Geotechnical Investigation

Proposed Residential Development
21 Withrow Avenue
Ottawa, Ontario

Report: PG4194-1 Revision 1

re: Geotechnical Response to City Comments
 Proposed Residential Development
 21 Withrow Avenue - Ottawa

Title: **SUMP PIT CONNECTION TO STORM SEWER WITH PORCH**

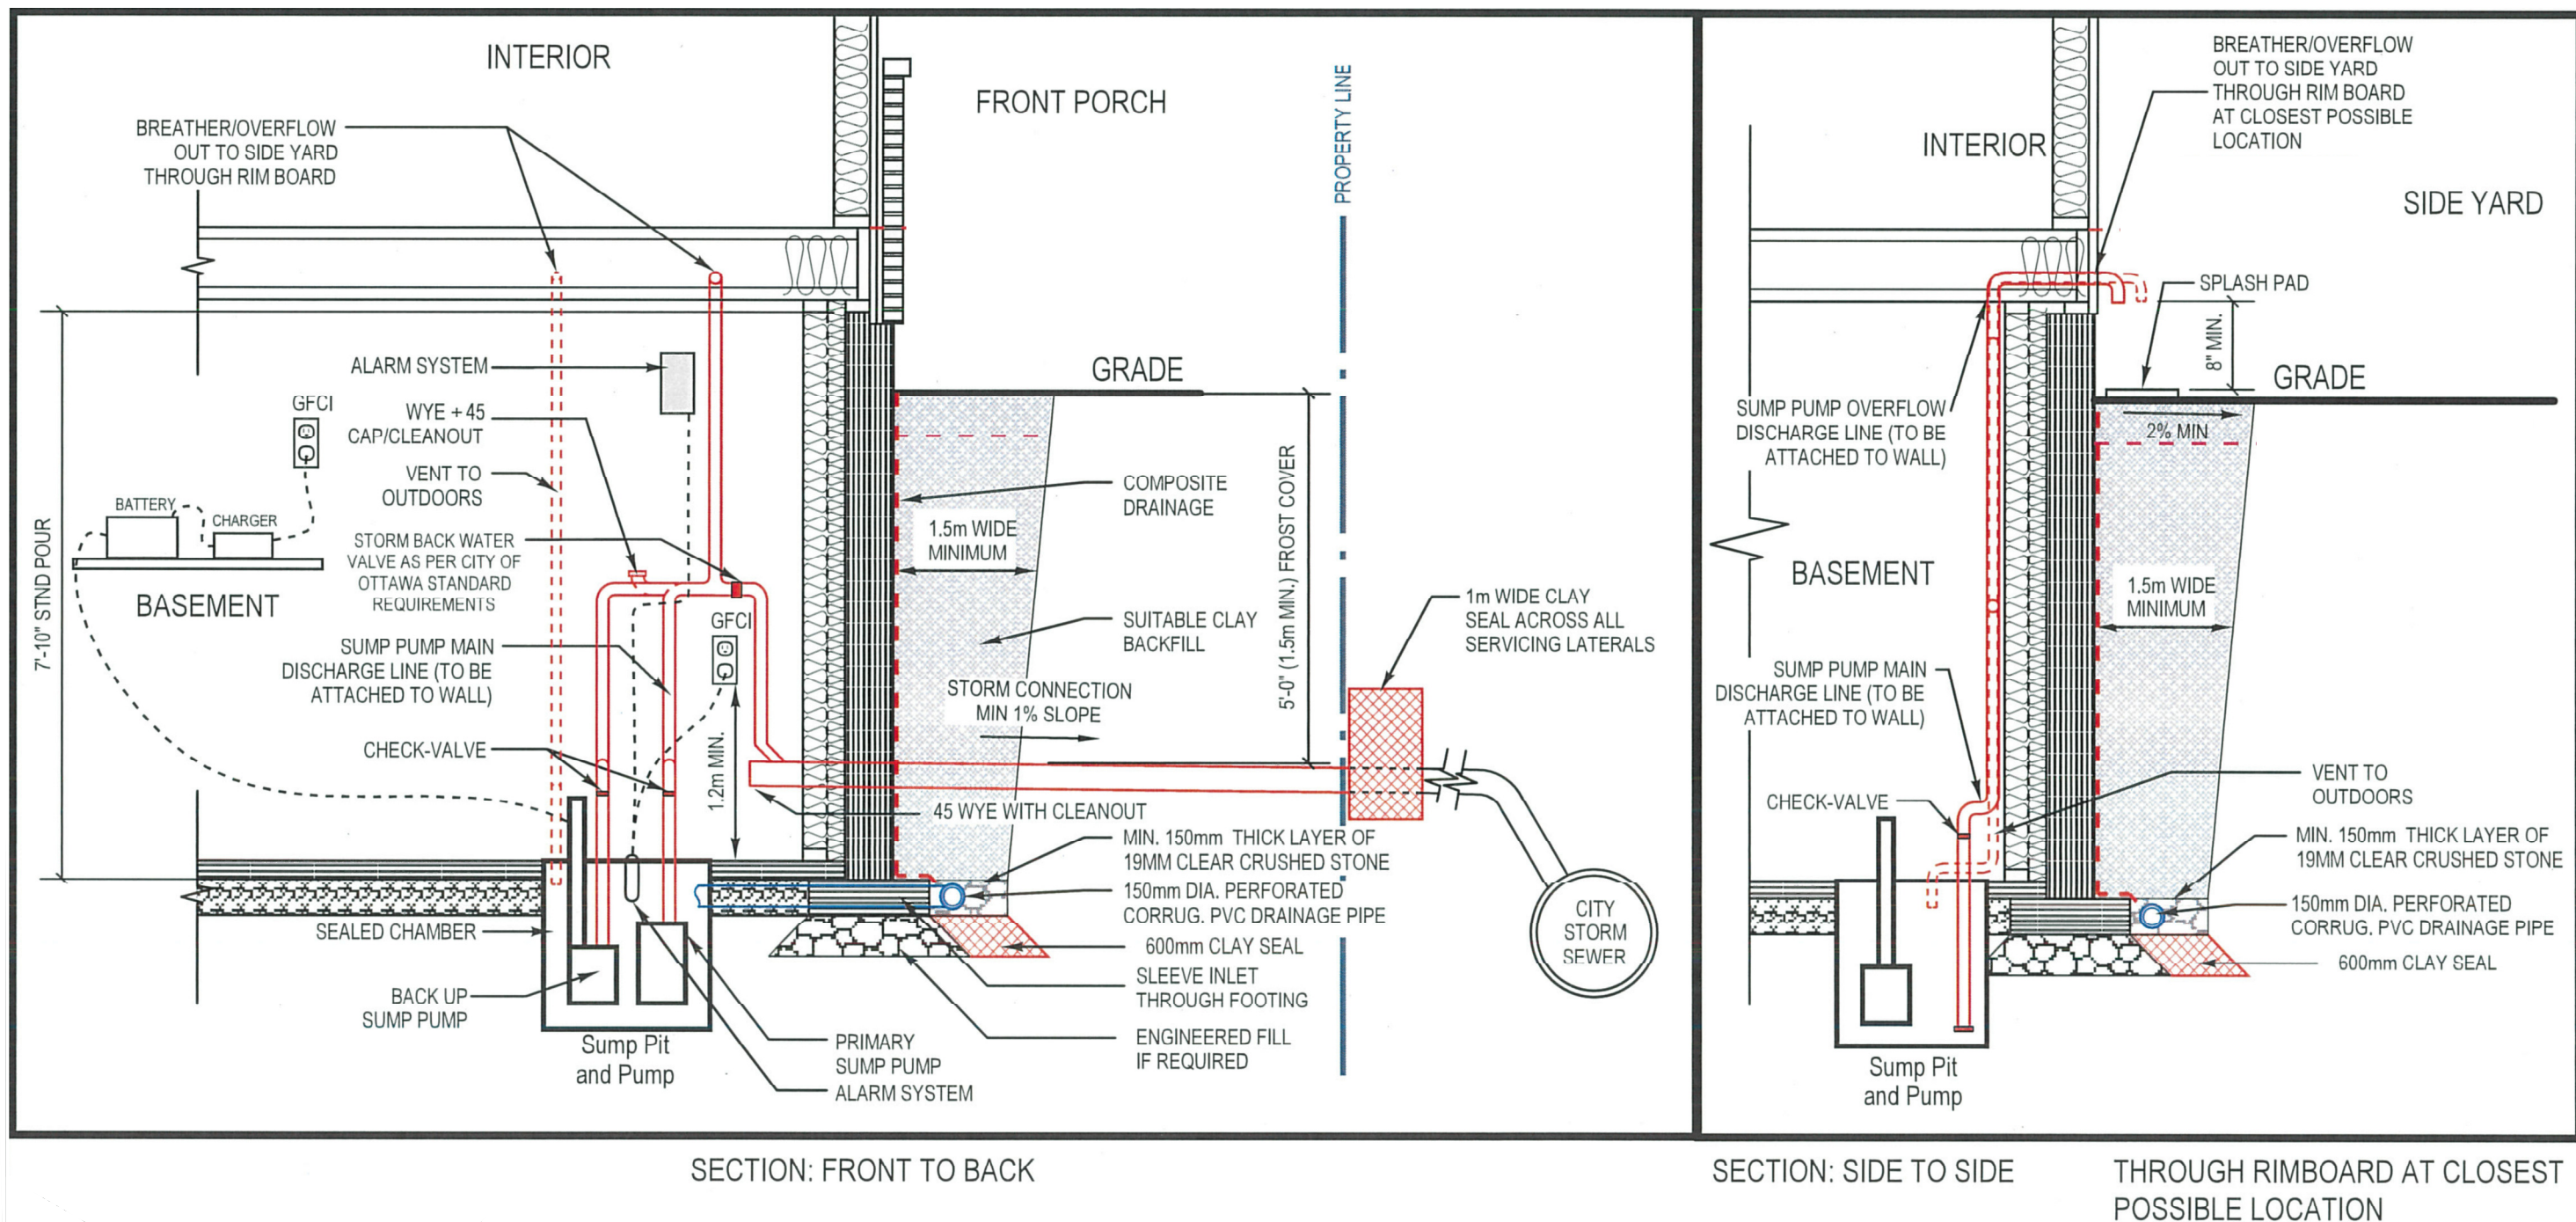
Comment 5: *The Geotechnical report shall detail the sump pump design.*

Response: The sump pump design is presented in Appendix 2 of Report PG4194-1 Revision 1 dated November 30, 2018.
